Serial No. 10/757,475

Docket No. YHK-0130

Amendment dated March 22, 2006

Reply to Office Action of December 29, 2005

FIG. 6

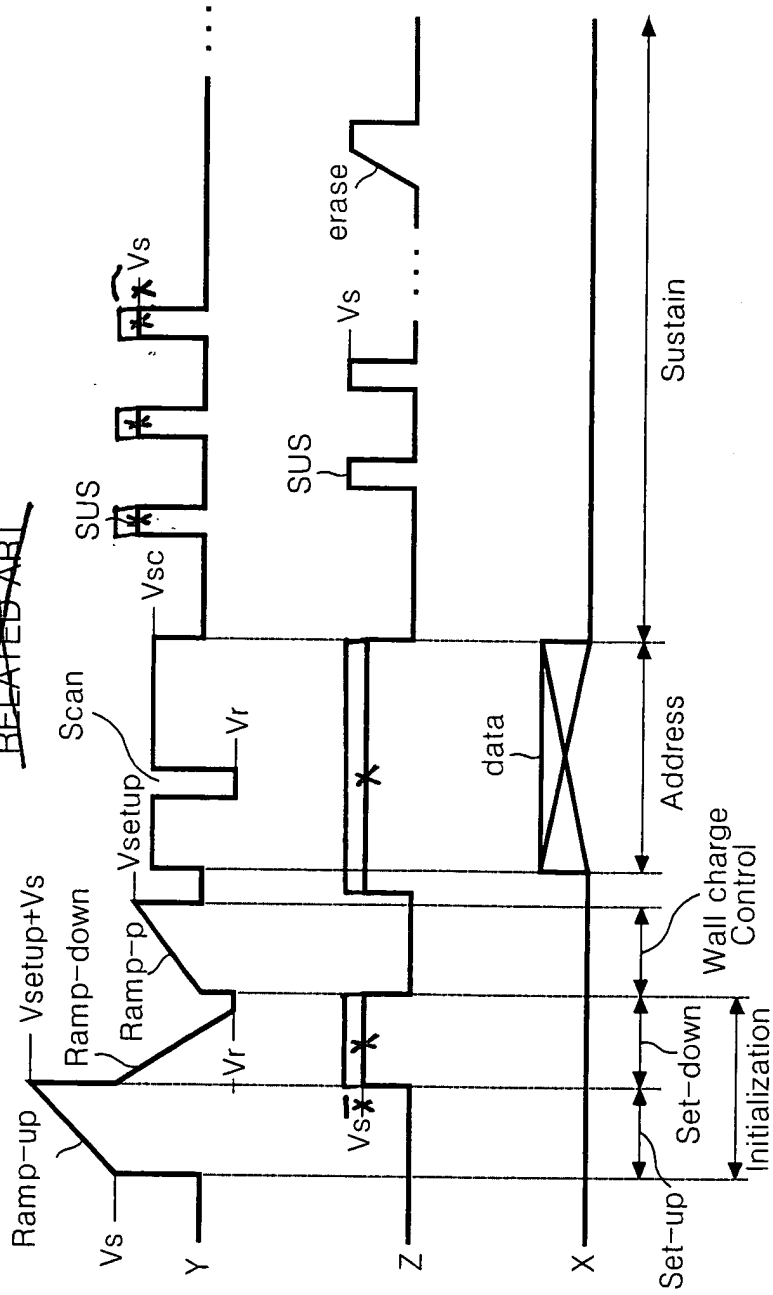
Figures 6 and 8 are amended for informalities. As shown in the marked-up copy, Figure 6 has been amended to delete the incorrect label "Related Art" and to show the proper levels of sustain voltage level V_s to be consistent with the specification and the labeling in the Figure. Likewise, Figure 8 is amended to correct the informalities in regard to the voltage levels in view of consistent figure labeling and the specification. Hence, entry of the amendments to the Figures 6 and 8 is respectfully requested.

~~RELATED ART~~
